INDESIT company

BCS313AVEI
BCS313AVEIS

F027595
F027596
F029149
F029150

0522067: SEALS FOR DOORS FOAMED AS ONE PIECE

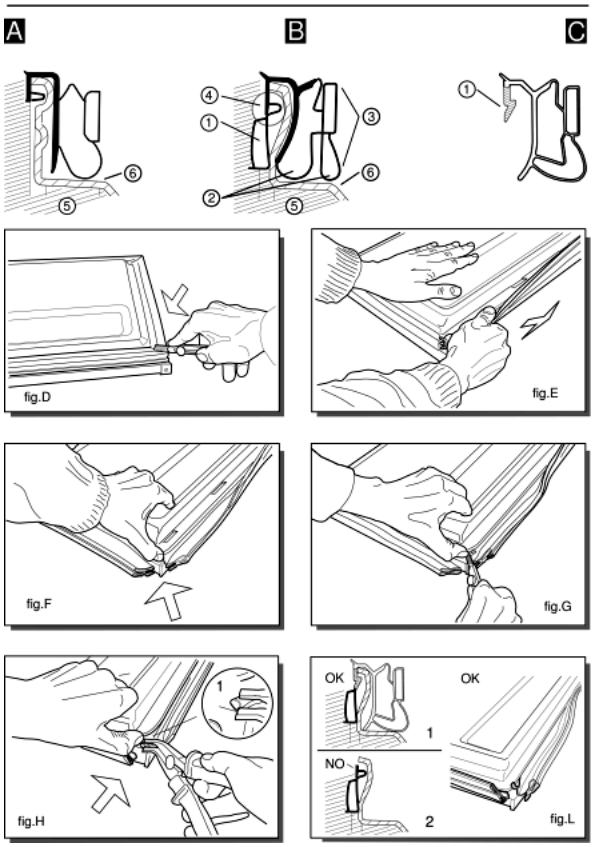
Various types of gaskets with different profile, as shown in figures (A) and (B), are used to fix the door (fig. A-5; B-5) and the inner door (fig. A-6; B-6) on the block foamed doors of combined freezers and refrigerators.
---Ilpea profile 245; 179; 412 (fig.A)
---Ilpea profile 287 (fig.B)
When replacing gaskets with profiles 245; 179; 412 these are fixed with screws (2 per corner) to the door.
Gaskets with profile 287 can not be used as spare parts but are designed to house the Ilpea type 900 gaskets (see figure C).
When replacing the gasket (287), once it is removed you will find a pocket (fig. B-1) between the door and inner door.
The rigid tooth (fig.C-1) of the gasket (900) is inserted inside between the pocket and the inner door, doing away with the need for screws.
Gasket with profile 287 is easy to identify since it has an exterior double edge (fig.B-2) which acts as a cushion when the door is closed.

To replace this gasket, follow these steps:
---Dismount the door and cut the four corners of the gasket along the joint (fig.D);
---lift the gasket and pull it carefully along its full length without tearing it (fig.E).
The purpose here is to detach the inner door slightly from the foam along the exterior edge for a depth equal to that of the gasket (fig.B-3);
---lift the corner of the inner door slightly, prising it up with your thumb (fig.F). Do not use a tool which might break the inner door;
---continue cutting the gasket inside the inner door for about 6 mm (fig.G);
---push in the tip of the pliers (type USAG N131) and pull outwards until you see the top edge of the pocket (fig. B-4) which is empty (fig.H-1);
---if you carry out this operation correctly (fig.L) you will be able to pull off the top edge of the pocket for the full length of the door.
If the gasket tears before the top edge (fig. L-2) you should repeat this operation from the other corner of the door.

---once the gasket (287), has been removed the space above the pocket (fig. L-1) can house the rigid tooth (fig. C-1) of the gasket 900.
When you fit this gasket ensure that it lies flush against the edge for the full length of the door.
If the rigid tooth is difficult to fit, eliminate any residues of foam between the door and the inner door in the gasket area.
fig.5131549A

n1030064: Elimination of sensor cage on 2002 range built-in fridge-freezers models BCS313

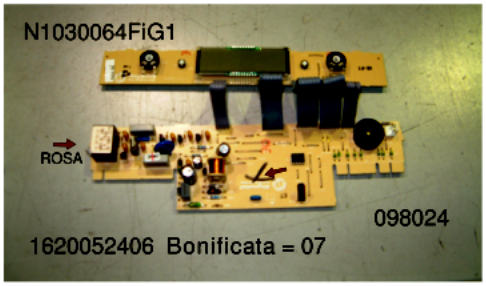
In April 2003 (serial no. 30407.0001) the Carinaro factory eliminated the cage protecting the fridge air sensor and moved the sensor 5-6 cm back on Ariston built-in electronic fridge-freezers.

This structural modification has involved the use of new electronic cards with warmer setting, because the sensor is less sensitive in the new position than in the previous more forward position with cage.

The Magnetek cards 162000524… (4083/PINK) and 162000525… (4082/WHITE) currently in stock in the Fabriano spare parts warehouse have all been replaced in order to be aligned with that used by production to date. These cards have been highlighted (see photo) with the marker pen, while the Magnetek codes (not higher than 162000524.06 and 162000525.07) are shown on the plates.
They will be managed with the following new Sat codes to enable correct ordering with respect to the previous ones.

098024 - 4083/pink new = (143091 ROHS)
098025- 4082/white new = (143092 ROHS)

The previous cards, with colder settings, do not have any highlighted marks and continue to be managed with the same Sat code (089759 and 088529=143093 ROHS) and must only be used on models with fridge air sensor in forward position and complete with cage.
Also, card 16200084501 will be managed with code 088529=143093 ROHS (4082/GREEN), currently used on the self-supporting fridge-freezer, which has the same settings as the previous card 16200052507 (4082/WHITE); whereas a card with red stamp on the pink plate (see photo) will be managed with code 089759.

Since November, electronic cards, with warmer settings, give the code 16200052407 for 4083/PINK and 16200052508 for 4082/WHITE on the plate, and must only be used on models with fridge air sensor without cage and in the back position.

N1030064FiG1
ROSA
098024
1620052406 Bonificata = 07

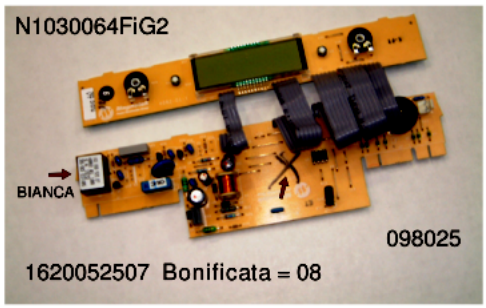
.
New parts
098024 = (143091 ROHS) CARD (MAGNETEK 4083/PINK) new (no-frost models without cage)
098025 = (143092 ROHS) CARD (MAGNETEK 4082/WHITE) new (static models without cage)

n1030100: New fixing bracket for combined 310-330 litre built-in models (Carinaro)

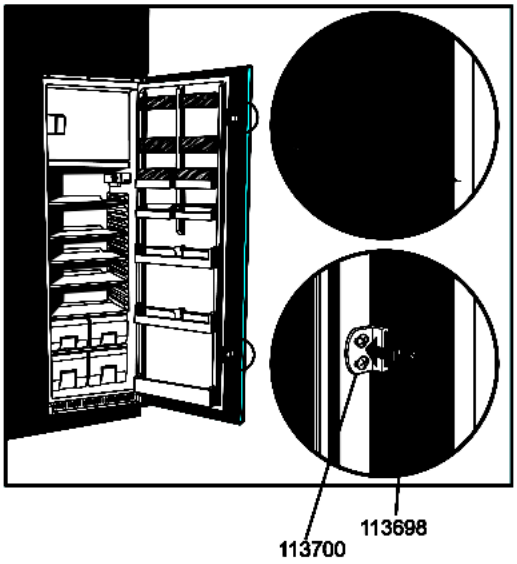
Since January 2006 (s/n 60123.0001) the fixing bracket, fitted on the cabinet, has been modified to strengthen the top hinge pin area.
The modification consists of having replaced the plastic bush with a threaded metal bushing (12x15) welded to the fixing bracket.
The new fixing bracket can also be fitted on premodification models.

144558 - HINGE-M8 FIXING BRACKET WHITE (LXDXH 540X90X22)

075191 - HINGE-FIXING BRACKET WHITE (LXLXH)540X90X22
057839 - WHITE BUSH (27X15X4.6) FOR PIN M8
110027 - WHITE BUSH 27X15X8) FOR PIN M8
